**BETTENDORF CITY COUNCIL  
COMMITTEE OF THE WHOLE  
COUNCIL CHAMBERS – CITY HALL**

**TUESDAY, FEBRUARY 17, 2026  
6:15 P.M.**

The City's Standard Specifications and Standard Drawings govern the types of materials, construction methods and other details for all public improvements. These specifications and detail drawings have not been updated in nearly twenty-five (25) years.

Engineering staff has reviewed the specifications manual and created an additional document, the City's Supplemental Specifications, which modify certain SUDAS sections to better reflect our needs. Staff is requesting that the current specifications and detail drawings be replaced with the SUDAS Specifications and the City Supplemental Specifications upon approval of the ordinance, for immediate implementation.

REVISION	
	1	05-23-25
	BETT6010.503	
STANDARD ROAD PLAN		
REVISIONS: Added Class I Bedding Material.		
SUDAS DIRECTOR		DESIGN METHODS ENGINEER
<b>SINGLE GRATE INTAKE SPECIAL</b>

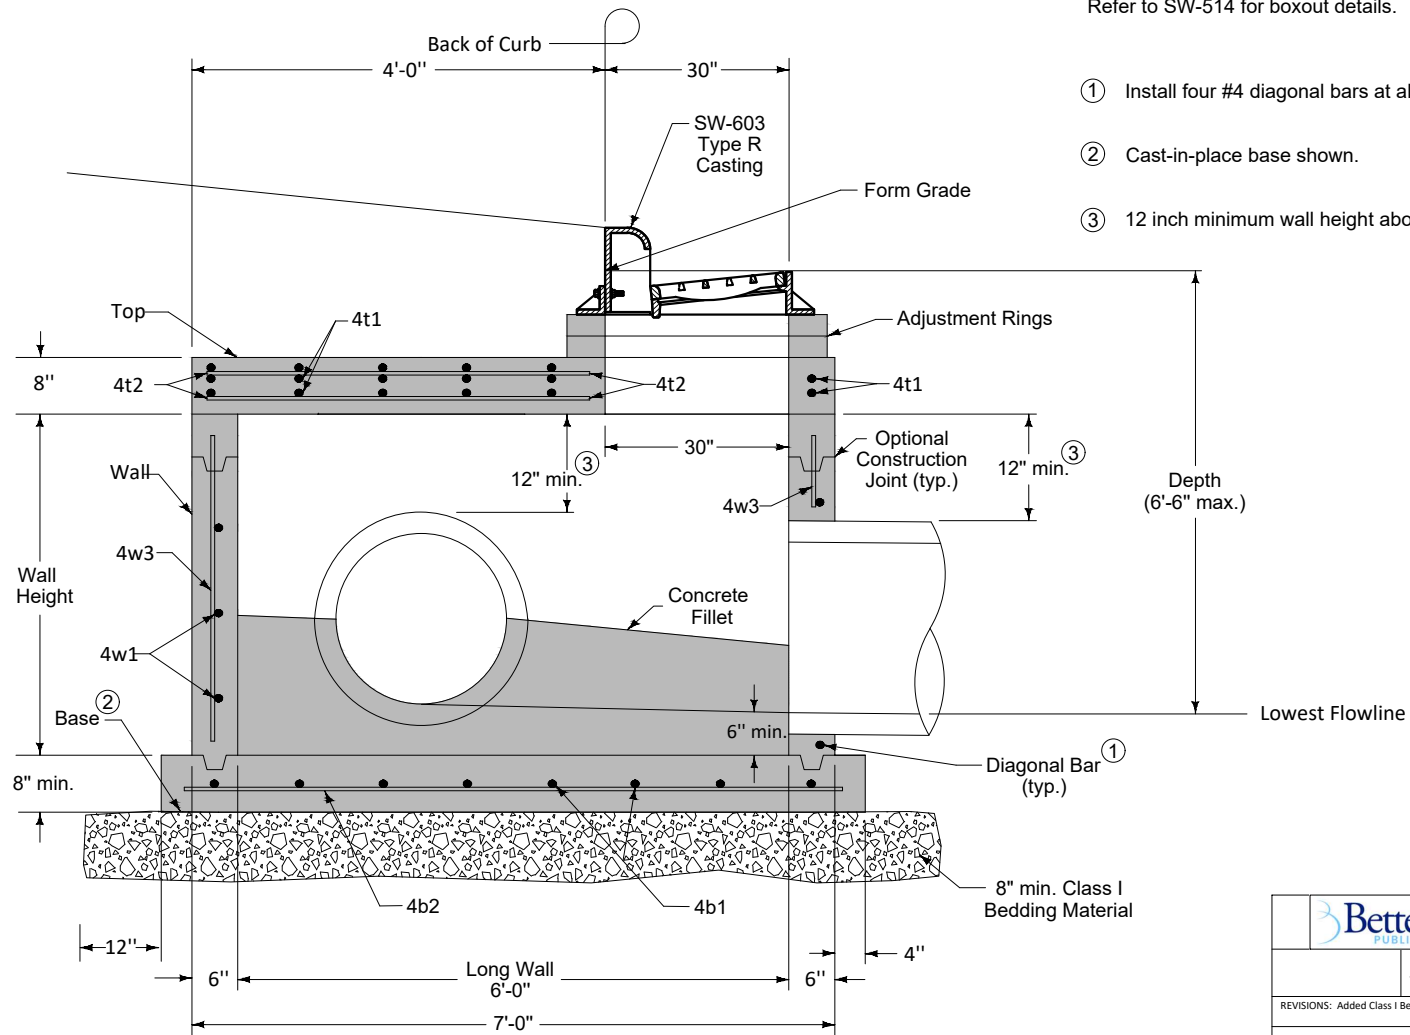
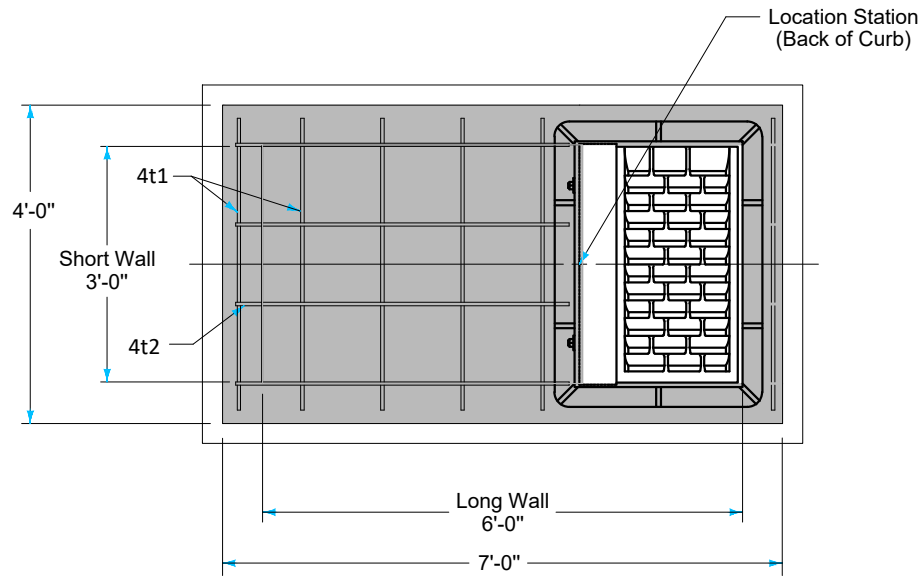
REPLACE Figure 6010.503 with Figure **BETT6010.503**

STANDARD ROAD PLAN	REVISION 1 05-23/25
		BETT6010.505 SHEET 1 of 2
REVISIONS:		
SUDAS DIRECTOR	DESIGN METHODS ENGINEER	
<b>DOUBLE GRATE INTAKE</b>

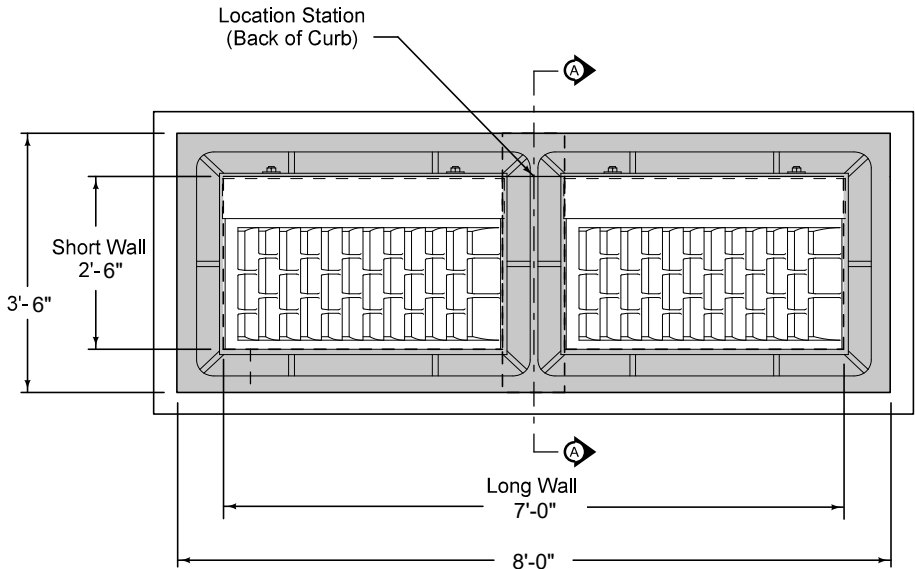
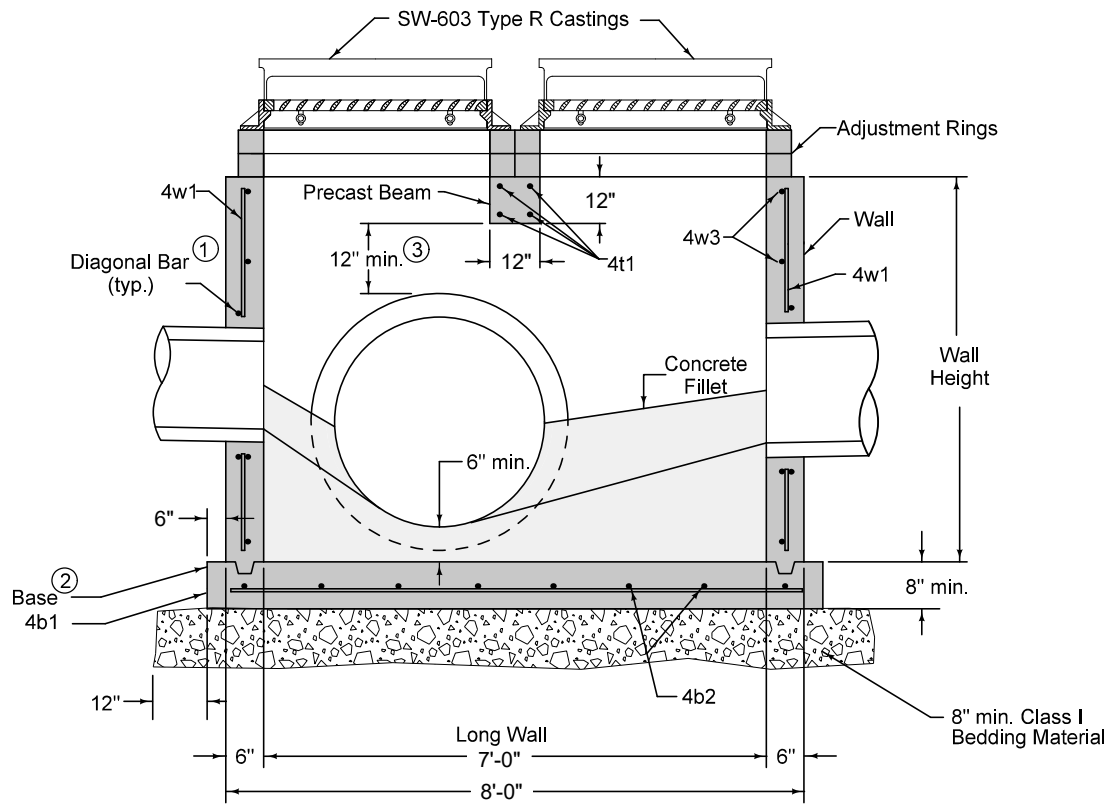
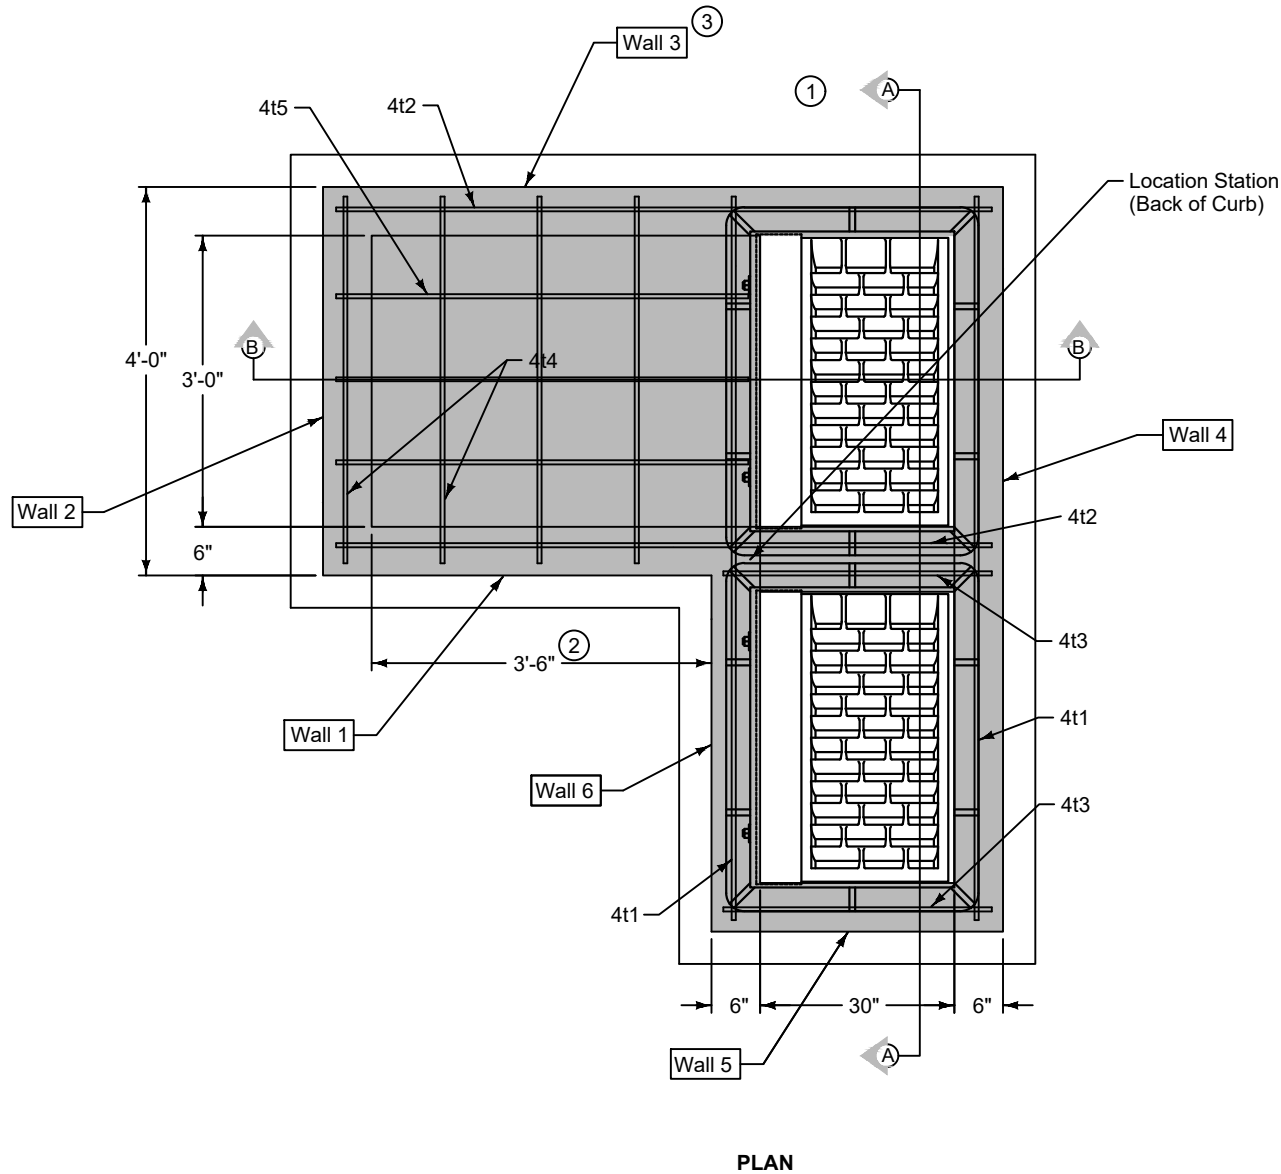
REPLACE Figure 6010.505 with Figure **BETT6010.505**

REVISION	
	1	05-28-25
STANDARD ROAD PLAN		BETT6010.506
		SHEET 1 of 2
REVISIONS: Added Class I Bedding Material.		
SUDAS DIRECTOR		DESIGN METHODS ENGINEER
<b>DOUBLE GRATE INTAKE SPECIAL</b>

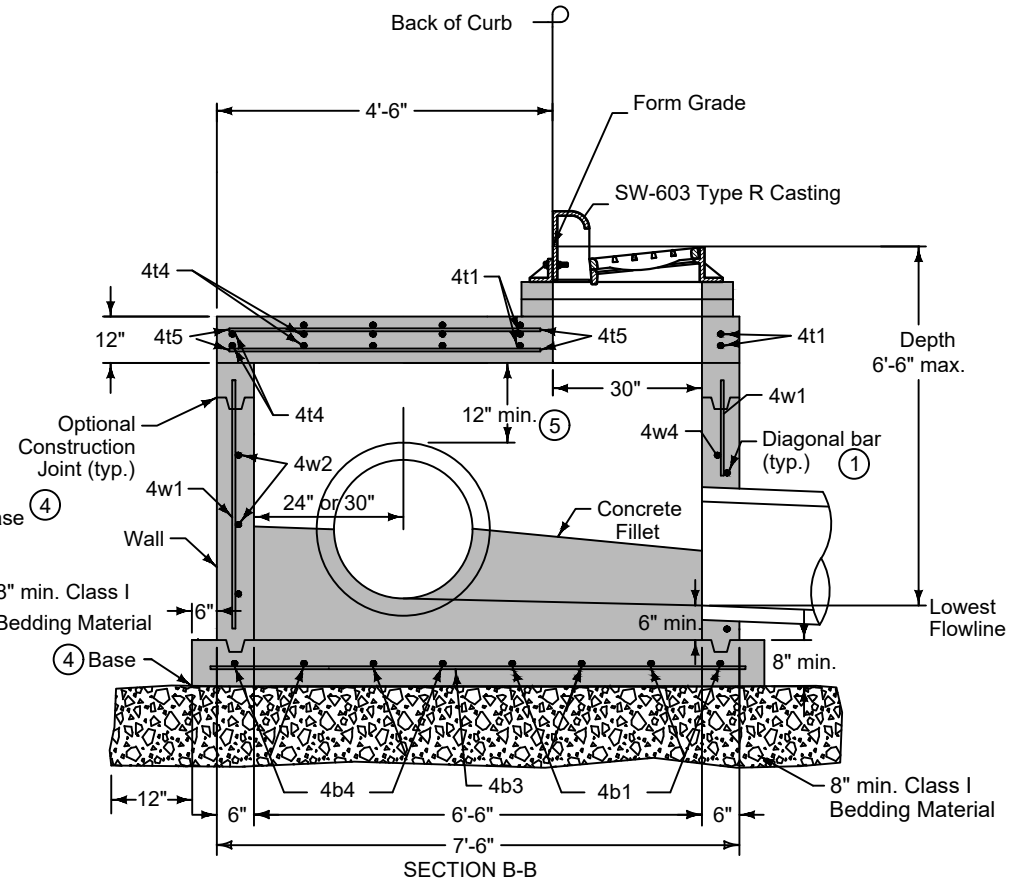
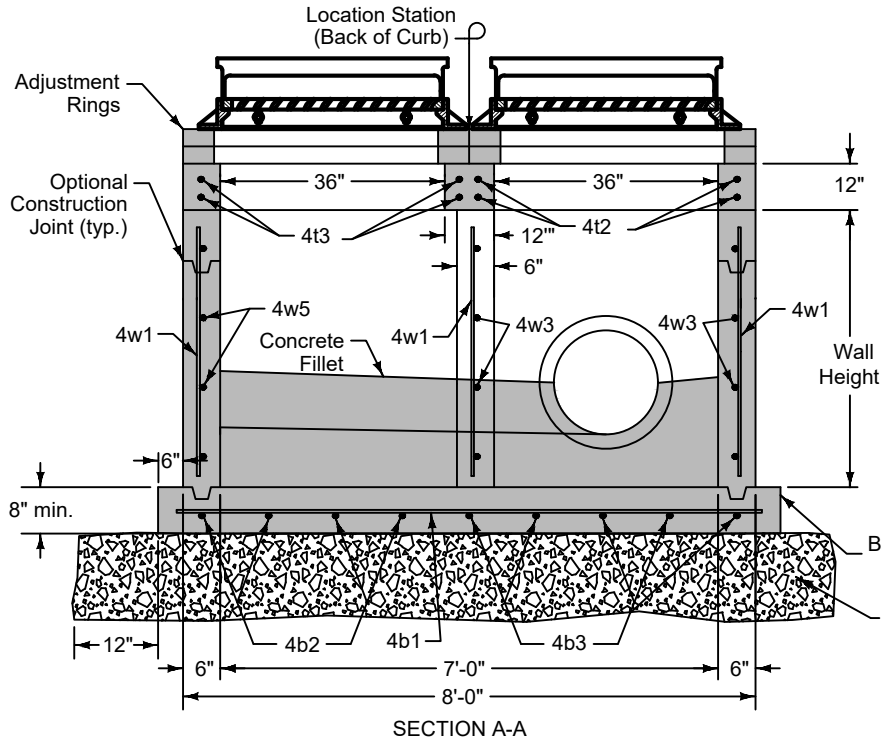
REPLACE Figure 6010.506 with Figure **BETT6010.506**

REVISION	
	1	05-28-25
STANDARD ROAD PLAN		BETT6010.514
		SHEET 1 of 2
REVISIONS: Added Class I Bedding Material.		
SUDAS DIRECTOR		DESIGN METHODS ENGINEER
<b>BOXOUT FOR GRATE INTAKES</b>

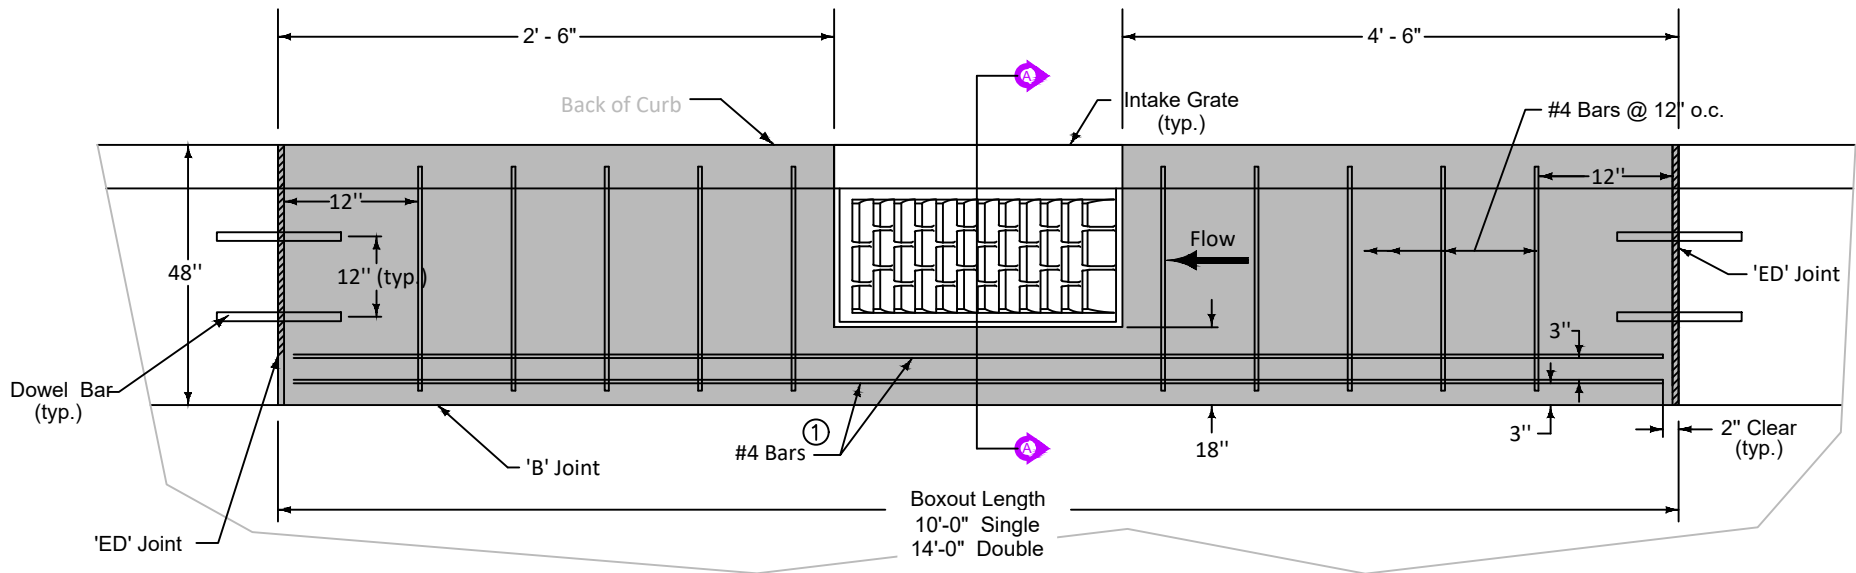
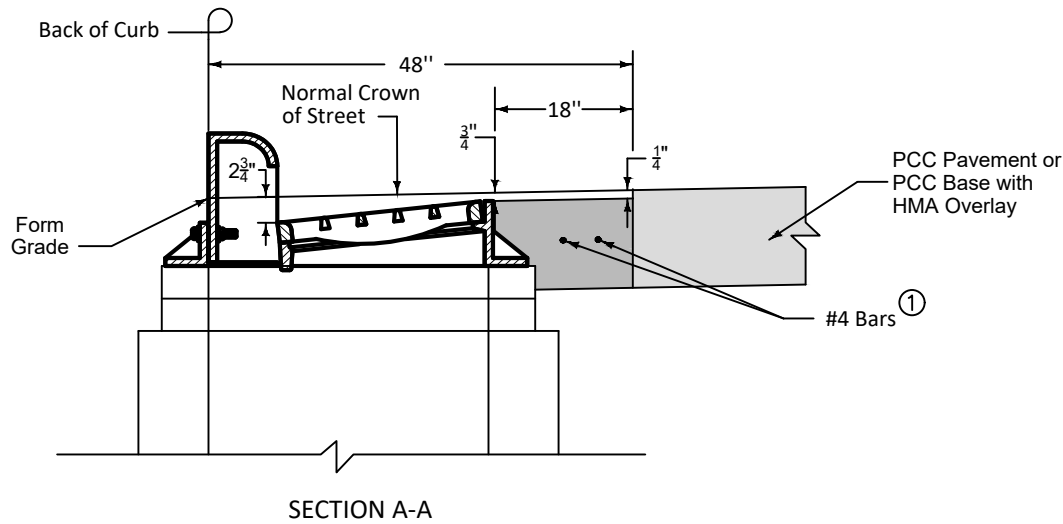
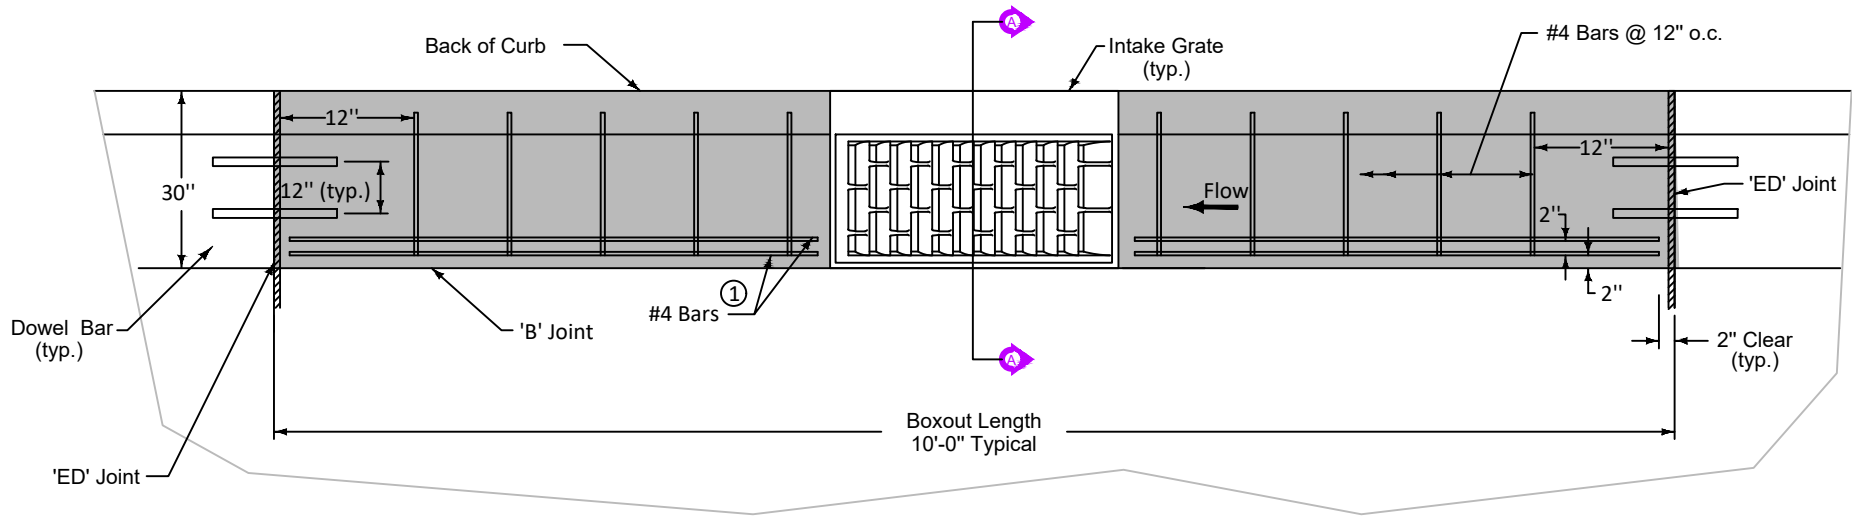
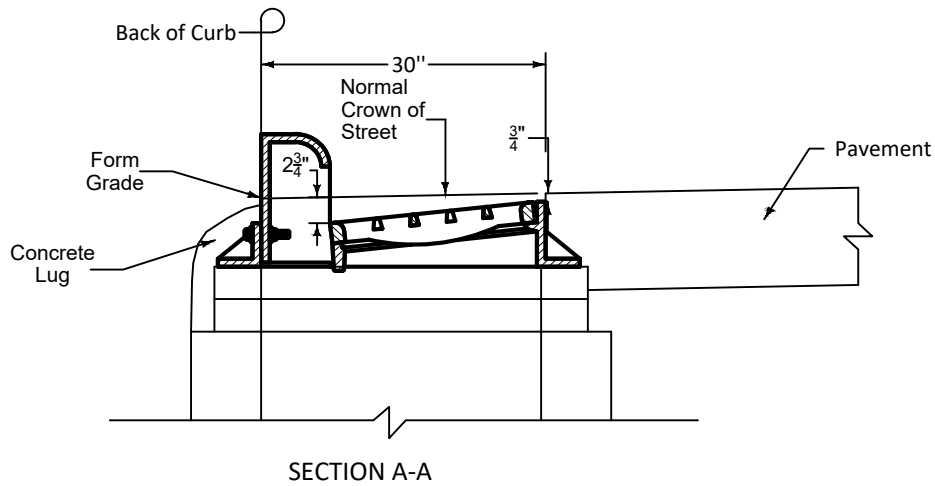
REPLACE Figure 6010.514 with Figure **BETT6010.514**
